**Addendum Number Two**  
To The Drawings and Specifications for  
**SEDGWICK COUNTY – Waiting Room Addition**

Issued: Thursday, August 20, 2020

You are hereby instructed to include in your bids the following changes and/or corrections to the Drawings and Specifications for the **Waiting Room Addition to the Sedgwick County Corrections building located at 622 East Central.**

2020  
SEDGWICK COUNTY  
CORRECTIONS - WAITING ROOM  
622 E. CENTRAL  
WICHITA, KANSAS 67202

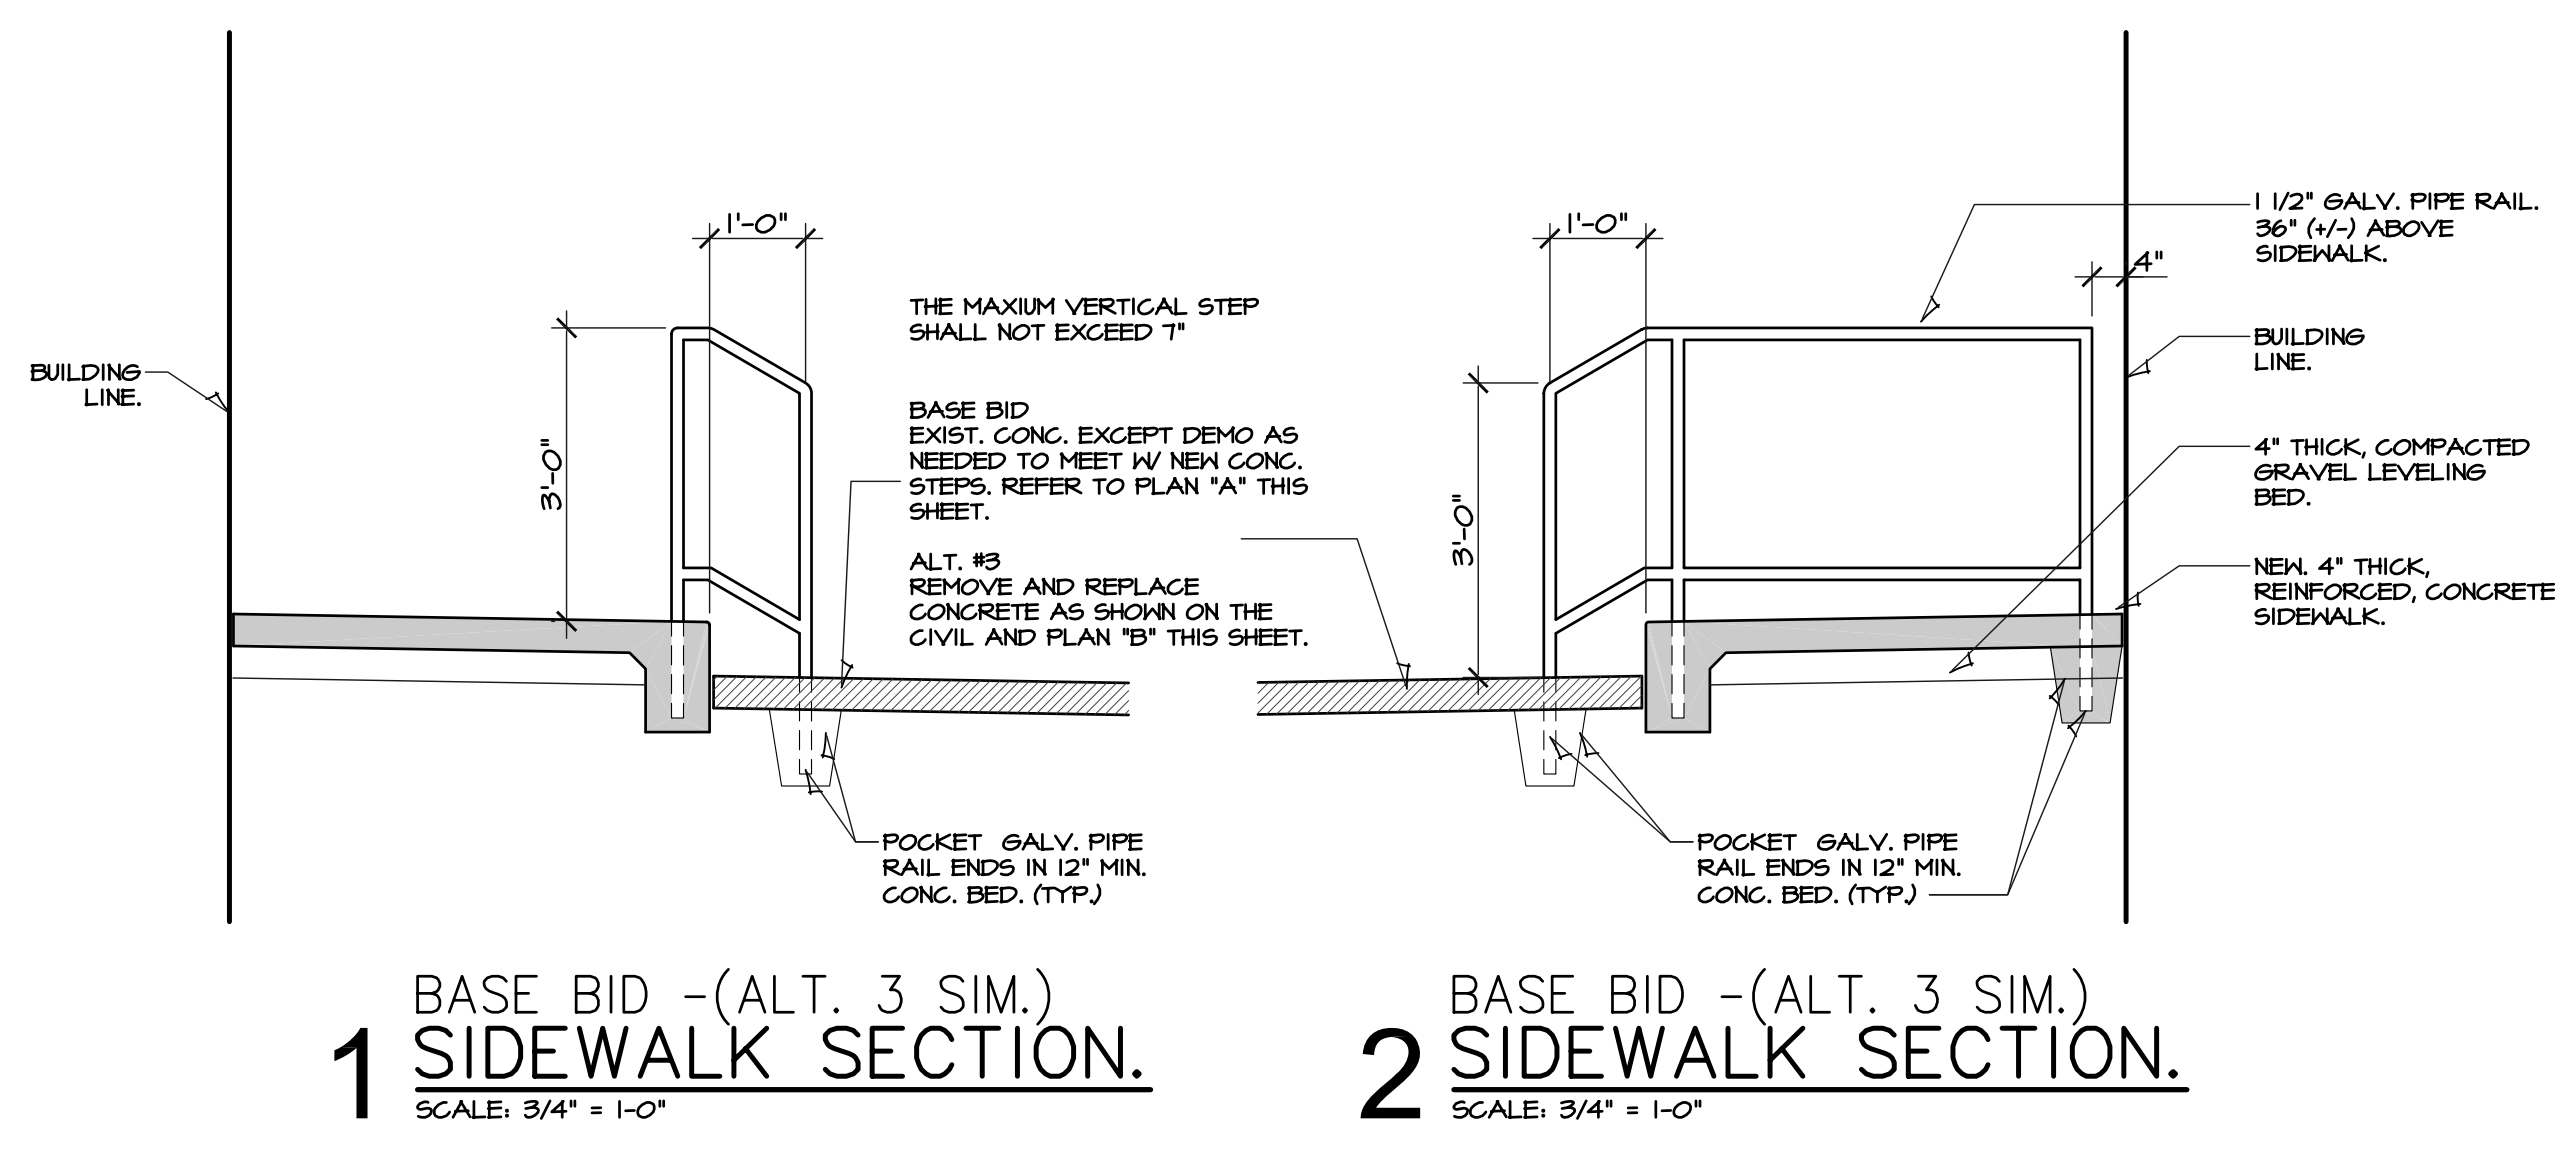
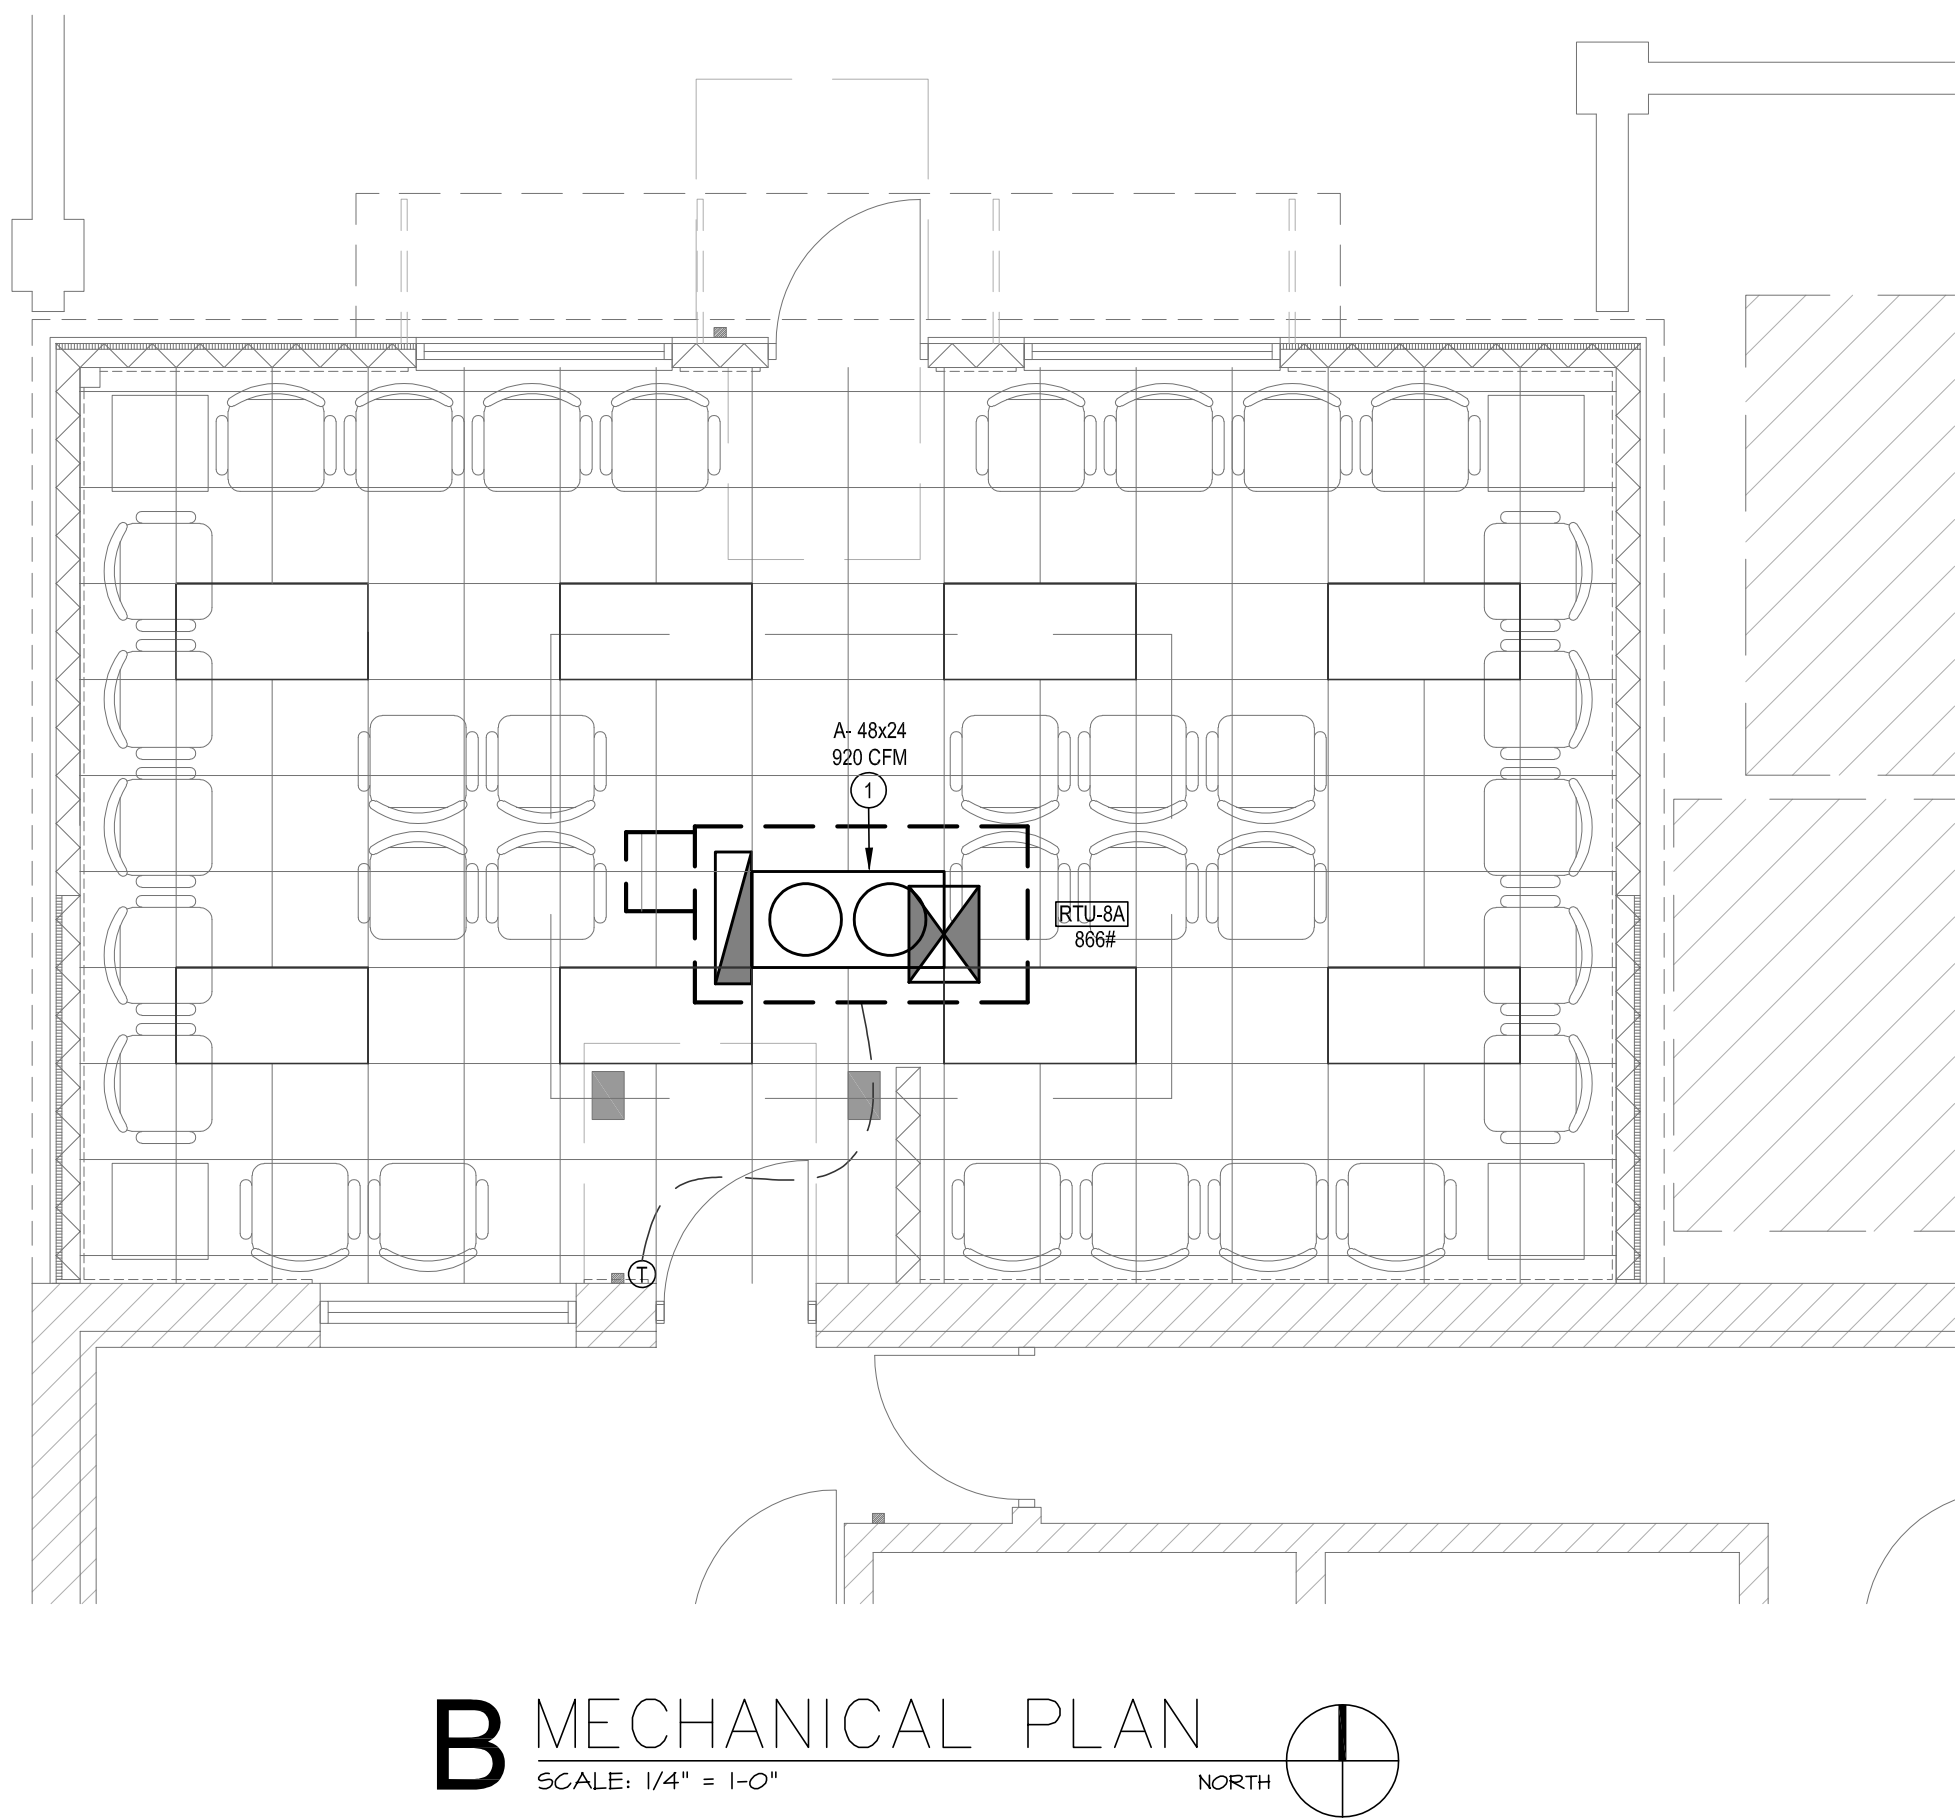
### 3.1 Sheet SP1.1

This sheet has been revised to show the new gas meter location. This sheet is reissued with this addendum.

- a. The Gas Meter shall be relocated to the West side of the existing building (in the parking lot). This will allow for the reconnection of the gas service prior to construction of the addition.

- b. The General Contractor shall pour pad on top of the existing paving for the gas meter and bollards to sit on. The pad shall be 4' square x a 6" thick concrete, reinforced with one layer of 6 x 6-W2.0 x W2.0 W.W.F. and #4 "L" bars at 24" o.c. drilled into the existing paving around the perimeter. The "L" bars shall be 12"x12".

- c. The General Contractor shall provide and install (2) 4" diameter steel bollards per the detail that is included with this addendum. The bollards shall be filled with concrete creating a domed top. The bollards shall be painted "safety yellow".
